Technical Note

Job name: Ffos y Fran Restoration Strategy

Ref. **Note on storage shed suitability for roosting bats**

Figure 1. The three sheds with arbitrary reference letters (A-C) corresponding to photographs in Table 1.

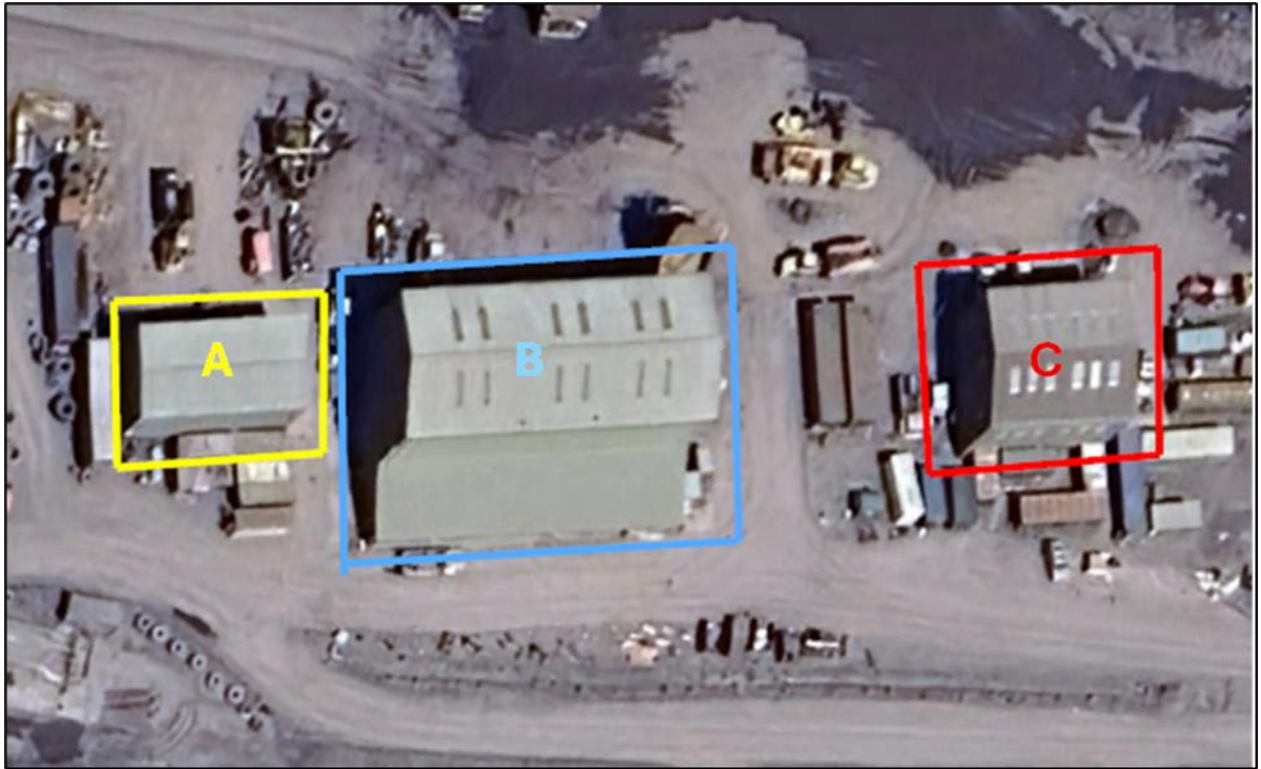
There are three storage and/or workshop sheds on this central area of the site that lie north of Bogey Road and used during the operational phase of the mine for servicing vehicles and materials storage (**sheds A-C; Figure 1**). The sheds comprise single-storey steel portal-frame industrial storage buildings with profiled metal wall and roof cladding (including rooflight panels on sheds B and C), set on a concrete slab and accessed via large roller shutter doors and a personnel door.

Roosting bats in the UK typically select buildings that provide sheltered cracks/crevices, small openings and roof voids, with a favourable and relatively stable microclimate, and (for many species) low levels of artificial lighting around roost access points. In contrast, modern metal-clad portal-frame sheds of this type generally offer few suitable roosting features (e.g., a lack of tiled roofs, soffits and complex junctions that create concealed crevices), and any minor gaps that do occur are more likely to be exposed to draughting and rapid temperature fluctuation due to the thin metal envelope and large door openings, making them less suitable for maintaining the stable conditions bats tend to use. In addition, as equipment stores, they are typically subject to regular human activity, vehicle/machinery movements and lighting, and guidance³ notes that lighting in the vicinity of roosts/access points can disturb bats and deter use where alternative roosts are available. On this basis, the three sheds are considered to have negligible potential to support roosting bats.
